# DRI REGIONAL REVIEW FINDING

**Name of Proposal:** 2023 Amsterdam Walk DRI 4065

**AMSTERDAM WALK**  
900 AMSTERDAM AVE NE, ATLANTA, GA 30306  
DRI #4065

DATE: 11/20/2023  
PROJECT NO: 019292043  
TITLE: DRI SITE PLAN  
SHEET NUMBER: C0-20

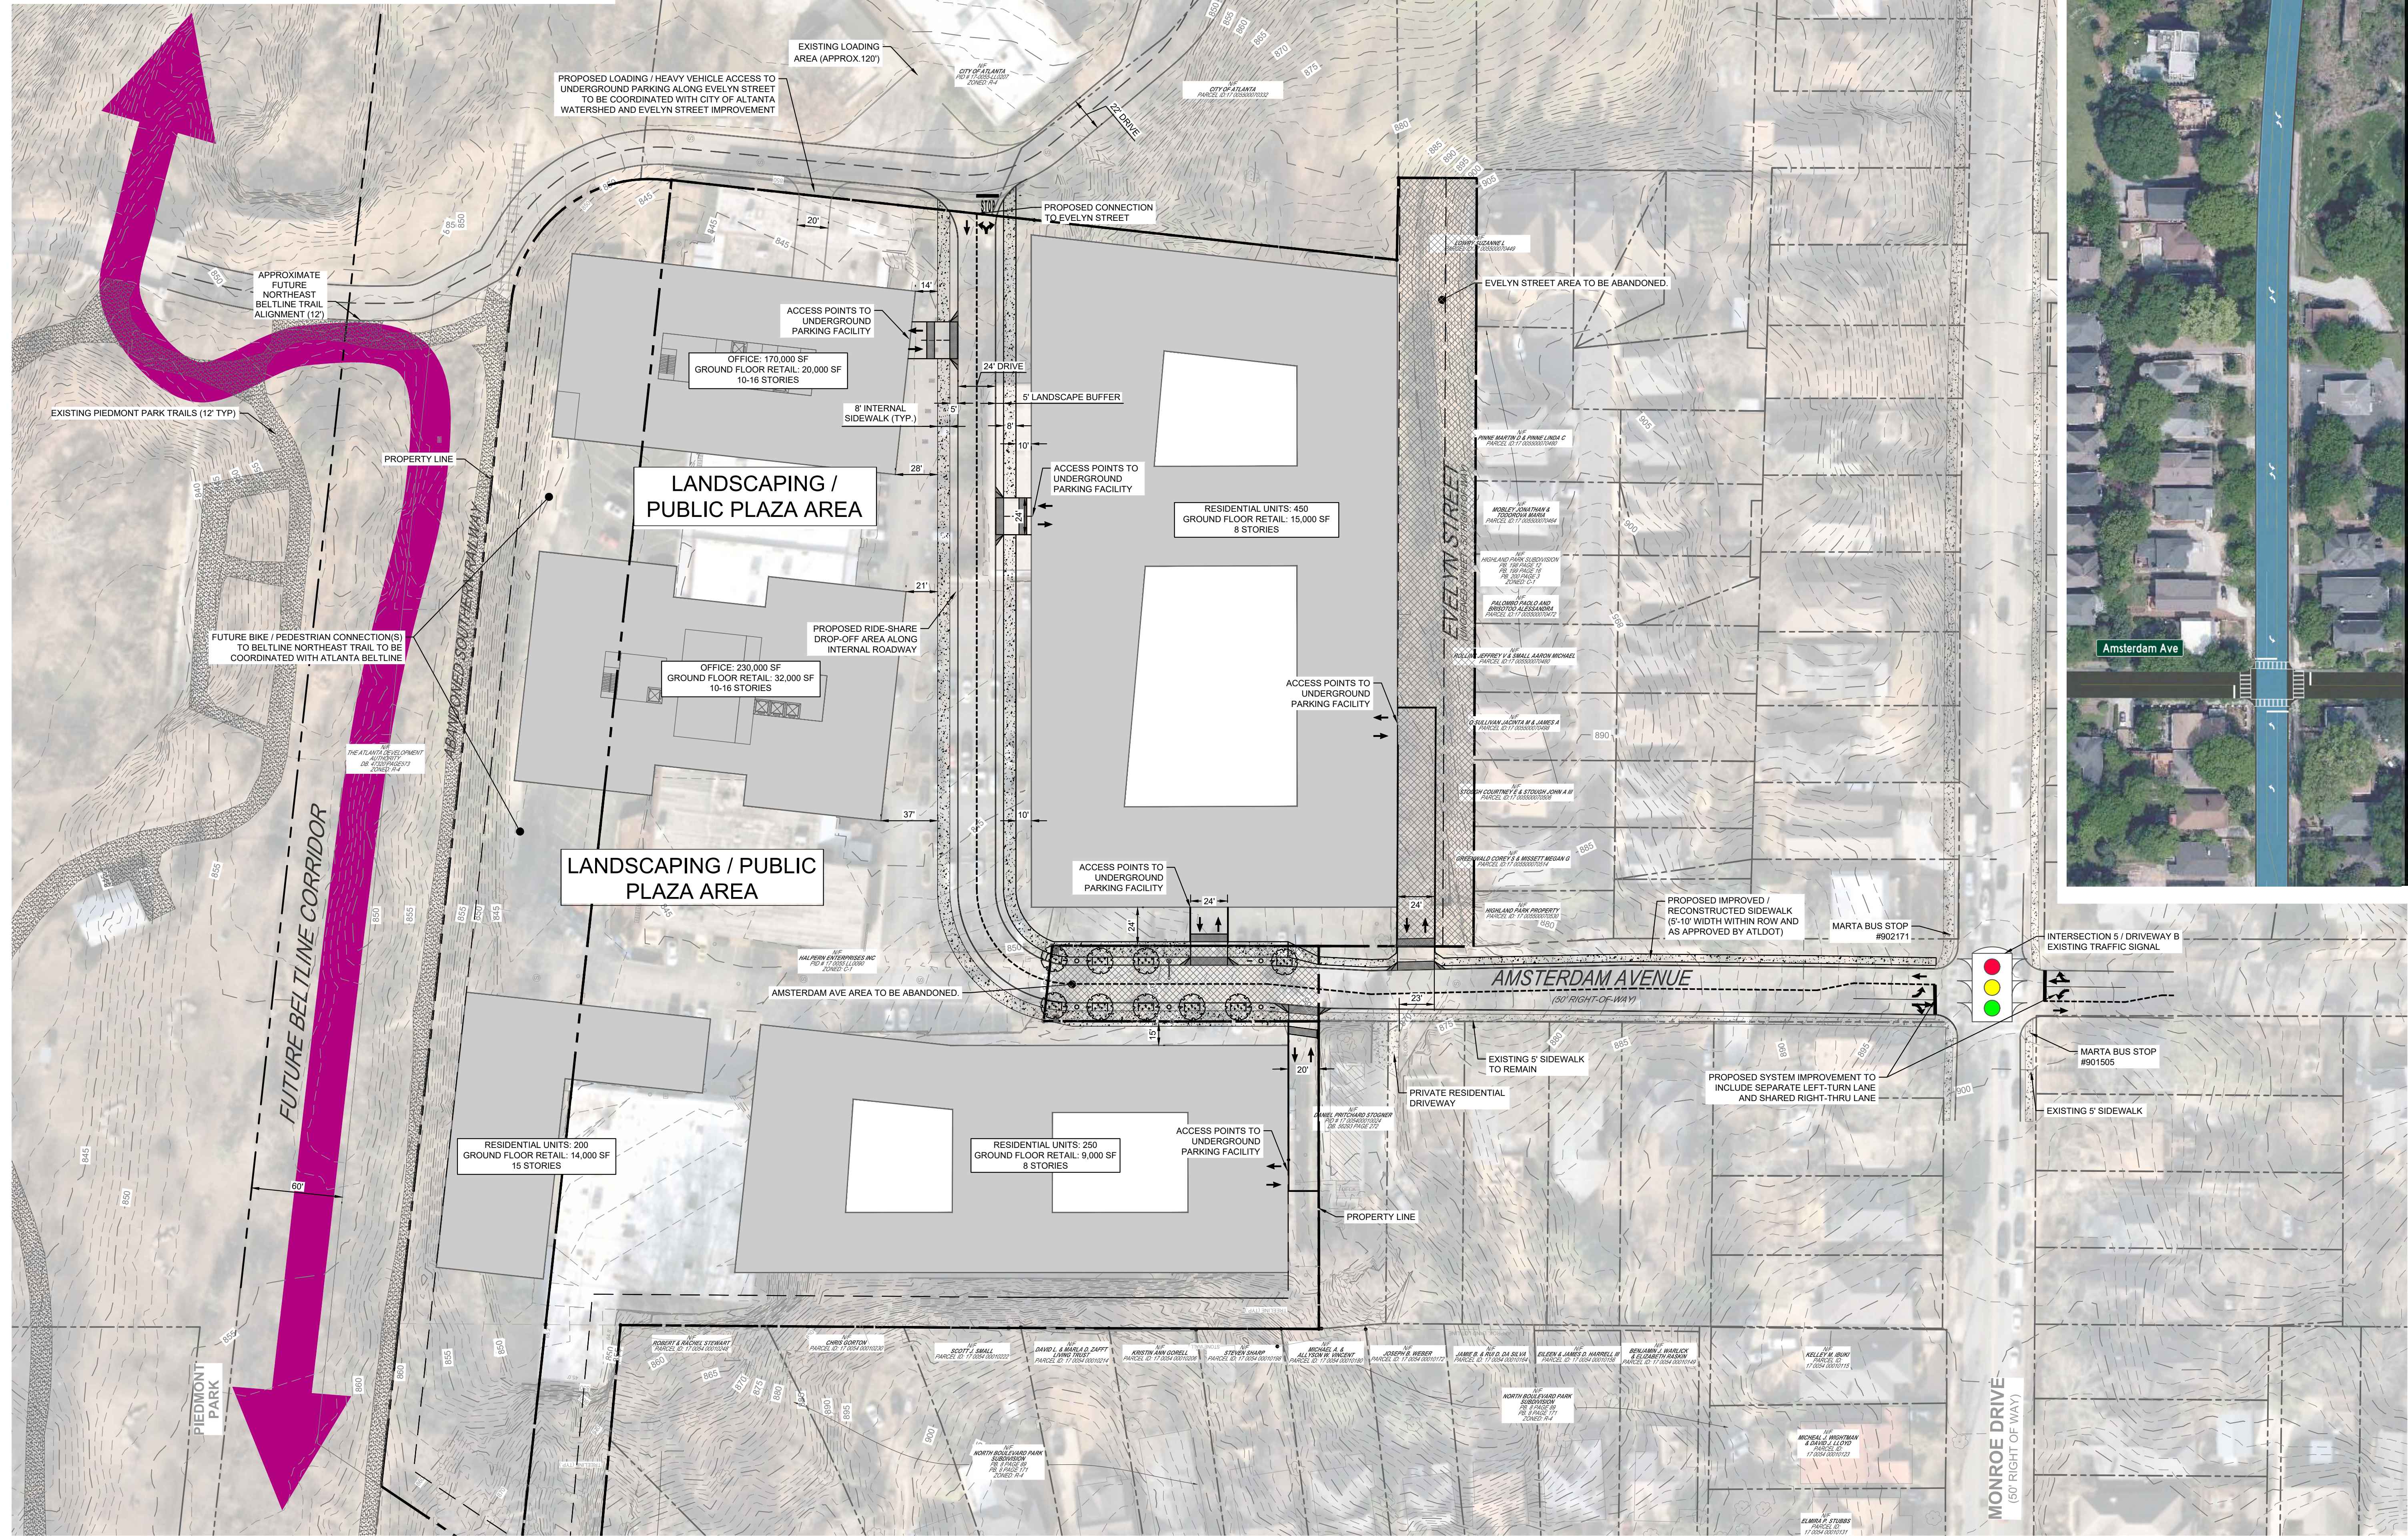
*The proposed expanded sidewalk on the north side of Amsterdam Avenue will be critical to ensuring easy and inviting pedestrian access from the surrounding neighborhood to the east and the MARTA stops on Monroe Drive.*

The proposed expanded sidewalk on the north side of Amsterdam Avenue will be critical to ensuring easy and inviting pedestrian access from the surrounding neighborhood to the east and the MARTA stops on Monroe Drive.

Pedestrian, bicycle and vehicular access to the project from Monroe Drive should be carefully coordinated with the City of Atlanta's pending plans for the Monroe Drive Complete Streets project.

Care should be taken to ensure that the constructed development provides an interconnected, functional, clearly marked and comfortable pedestrian experience on all driveways, paths, entrances, and parking areas. To the maximum extent possible, new driveways and intersection corners where pedestrians will

**Note: Proposed bike/pedestrian bike connections shown on westside of site plan to be coordinated with the Atlanta Beltline.**
